Countries: CANADA, MEXICO, UNITED STATES Document ID: IK2300042
 Availability: ISIS, Bus ISIS, NotSIR Revision: 1
 Major System: ELECTRIC VEHICLE Created: 7/30/2025
 Current Language: English Last Modified: 8/13/2025
 Other Languages: NONE Author: Joseph Hampton
 Viewed: 84

Title: Driveline Vibration w/SPL170

Applies To: 2021 - 2025 International® IC Bus® Electric CE Series

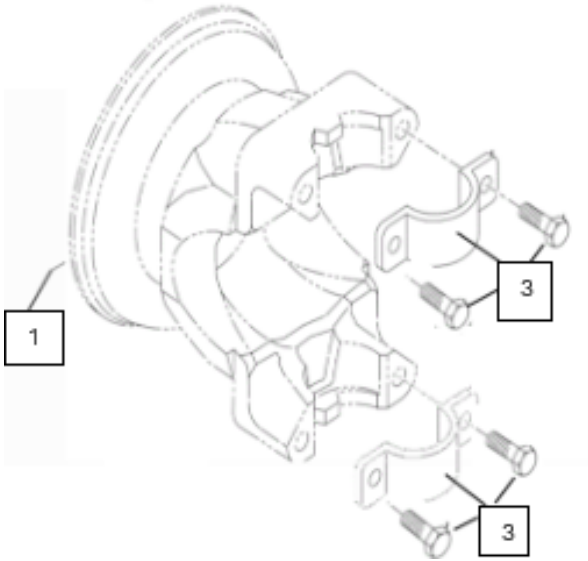
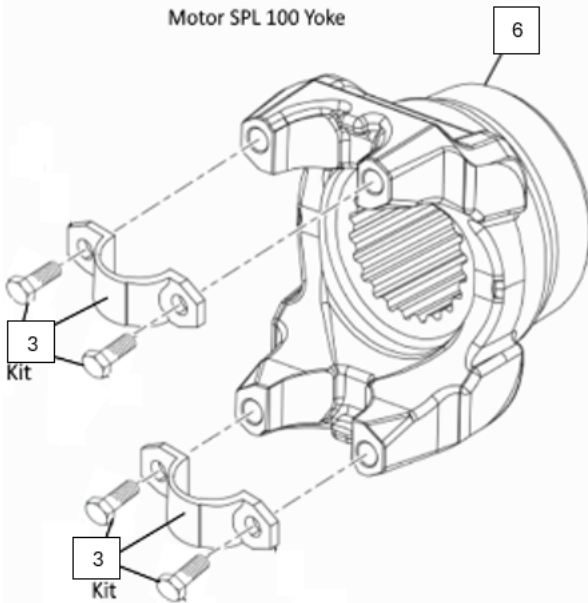
Service Parts for the SPL100 retrofit work will be ordered according to vehicle Rear Axle Feature Coding. SWB Buses built with Feature Code 0014AKT or 0014AKR AXLE, REAR, {Dana Spicer 21060SH} 21,000-lb Capacity will require different components at the differential than LWB Buses built with Feature Code 0014ERW AXLE, REAR, {Dana Spicer S23-172F} 23,000-lb Capacity. See Below.

Item #	Part Number	0014AKT / 0014AKR Kit Description	Quantity Required	Not
1	4110949C91	DRIVE SHAFT END YOKE, SPL100 SERIES, 39 SPLINE COUNT, BS YOKE STYLE	1

2	4252904C1	SPACER, MOTOR YOKE	1	
3	1685128C91	KIT, U JOINT STRAPS AND BOLTS	2	P/N
4	DS127589	NUT, PINION FLANGE, DIFFERENTIAL, M36 X 1.5 (55mm Socket)	1	
5	2527114C91	MOTOR YOKE NUT HW-2030 W/ COTTER PIN	1	
6	4657334C1	YOKE, SLIP JOINT, SPL100 MOTOR	1	
7	410LTJ0760	SHAFT, DRIVE LINE PROP, PROP SHAFT (217" Wheel Base)	1	DS

Differential SPL100 Yoke

Motor SPL 100 Yoke

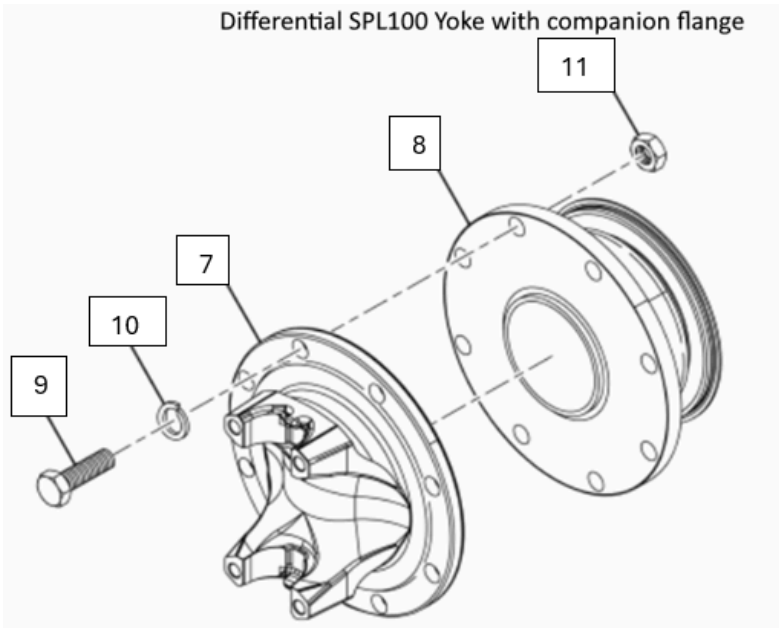
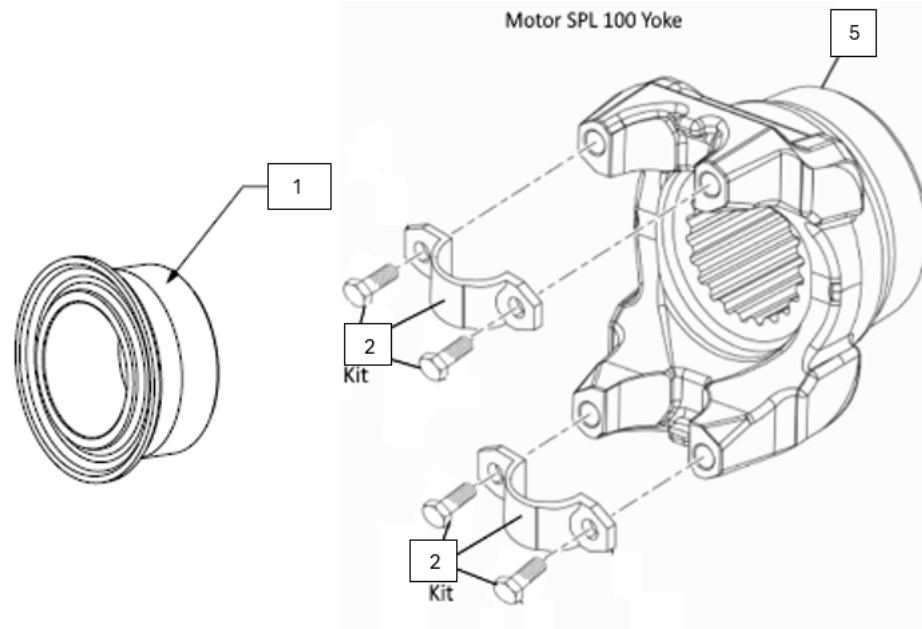
Item #	Part Number	0014ERW Kit Description	Quantity Required	Notes
1	4252904C1	SPACER, MOTOR YOKE	1	
2	1685128C91	KIT, U JOINT STRAPS AND BOLTS	2	
3	2598104C1	NUT (Axle Yoke Nut)	1	
4	2527114C91	MOTOR YOKE NUT HW-2030 W/ COTTER PIN	1	
5	4657334C1	YOKE, SLIP JOINT, SPL100 MOTOR	1	
6	410LTJ0760	SHAFT, DRIVE LINE PROP, PROP SHAFT (254" & 276" Wheel Bases)	1	DS100DS
7	2527001C1	FLANGE, YOKE	1	
8	2527002C1	FLANGE, COMPANION DRIVE SHAFT	1

9	2527003C1	BOLT, DRIVE SHAFT	8	
10	2527004C1	WASHER, LOCK	8	
11	2527005C1	NUT, DRIVE SHAFT	8
